Title - Sujet Crane Rental Services	
Solicitation No. - N° de l'invitation EP168-203174/A	Amendment No. - N° modif. 001
Client Reference No. - N° de référence du client 20203174	Date 2020-06-16
GETS Reference No. - N° de référence de SEAG PW-\$\$HS-652-78732	
File No. - N° de dossier hs652.EP168-203174	CCC No./N° CCC - FMS No./N° VME
Solicitation Closes - L'invitation prend fin at - à 02:00 PM on - le 2020-06-23	
Time Zone Fuseau horaire Eastern Daylight Saving Time EDT	
F.O.B. - F.A.B. Plant-Usine: <input type="checkbox"/> Destination: <input type="checkbox"/> Other-Autre: <input type="checkbox"/>	
Address Enquiries to: - Adresser toutes questions à: Lafontaine, Raphael	Buyer Id - Id de l'acheteur hs652
Telephone No. - N° de téléphone (613) 296-5030 ()	FAX No. - N° de FAX () -
Destination - of Goods, Services, and Construction: Destination - des biens, services et construction:

AMENDMENT 001

This amendment 001 is raised to publish questions and answers received by potential Bidders, as follows:

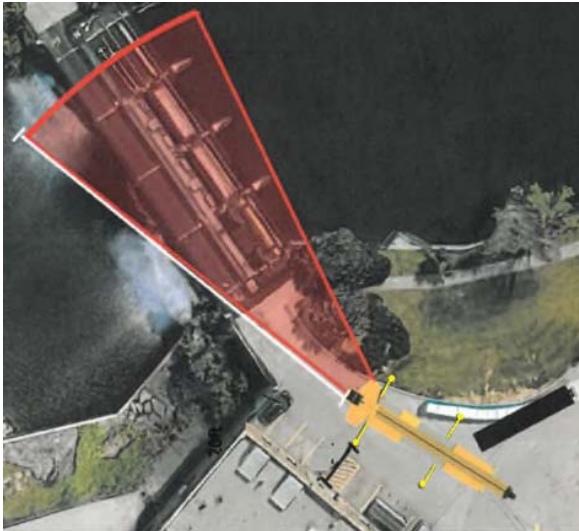
Q7. : See attached drawing showing footprint and set up location suggested by our company. With this size of crane the outrigger span is 30 - 32 ft including outrigger pads. With the size of crane required and the spacing needed for outriggers to setup we have to be a fair bit farther back from the dam to get the job done while also providing 20 ft from the building beside. Can the distance from the building be adjusted in the Statement of Work?

A7. : The problem is that we have no information on the construction of the wall which runs underneath the parking spaces in front of the heating plant, nor of the slab which is the roof of that extended basement area. Hence we have no way of assessing the effect of the outrigger load on the structure and this is the reason for the requirement for setback distance. We cannot change it.

On the other hand, note that the outriggers can be placed amongst the pine trees, to the right of the crane in your setup drawing (see SOW section A3.4.1 and answer to Question #1). It appears that this would allow you to drive the crane somewhat closer to the dam than is shown in your drawing, if you stay close to the trees on the right.
